Access Compliance Report

Public Rights-of-Way

Intersection ID: 10040201	Main Street: TYVOLA_RD	Cross Street: N/A	Location: NW
ADA ID: 0EE3A790BB7D	Ramp Type: Perp	Initial Pass/Fail: Fail	Overall Compliance: No
Severity Score: 22.5			
Codes/Mitigation Info/Possible Solution		Field Measurements/Component Compliance

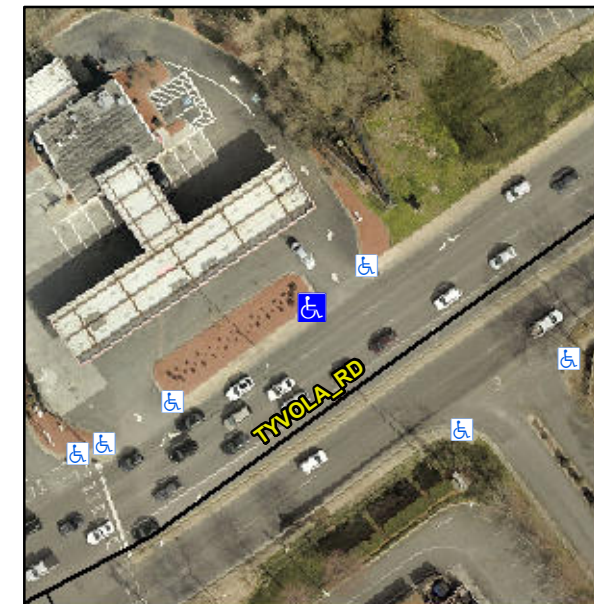
Not Found, R304.5.1, R304.2.2, R304.5.3

Compliance	Description	Data	Compliance	Description	Data
N/A	Ramp Length (in)	62.0	No	Ramp Slope (%)	8.7
No	Ramp Width (in)	39.0	No	Ramp XSlope (%)	3.2
N/A	Flare Type LT	N/A	N/A	Flare Type RT	N/A
N/A	Flare Slope LT (%)	N/A	N/A	Flare Slope RT (%)	N/A
N/A	Flare Traversable LT?	N/A	N/A	Flare Traversable RT?	N/A
N/A	Landing Length (in)	N/A	N/A	DWS Provided?	N/A
N/A	Landing Width (in)	N/A	N/A	DWS Contrast?	N/A
N/A	Landing Slope (%)	N/A	N/A	DWS Length (in)	N/A
N/A	Landing X Slope (%)	N/A	N/A	DWS Full Width?	N/A
N/A	Landing Curb? (Y/N)	N/A	N/A	DWS Offset (in)	N/A
N/A	Shared Landing?	N/A			
N/A	Gutter Ponding?	N/A	N/A	Gutter Slope (%)	N/A
N/A	Gutter Lip Ht (in)	N/A	N/A	Gutter X Slope (%)	N/A
N/A	Painted X Walk1?	No	N/A	Painted X Walk2?	N/A
	X Walk 1 Direction	To NE		X Walk 2 Direction	N/A
N/A	X Walk 1 Width (in)	N/A	N/A	X Walk 2 Width (in)	N/A
	X Walk 1 Slope (%)	2.0		X Walk 2 Slope (%)	N/A
	X Walk 1 X Slope (%)	2.6		X Walk 2 X Slope (%)	N/A

Remove & Replace Entire Ramp.
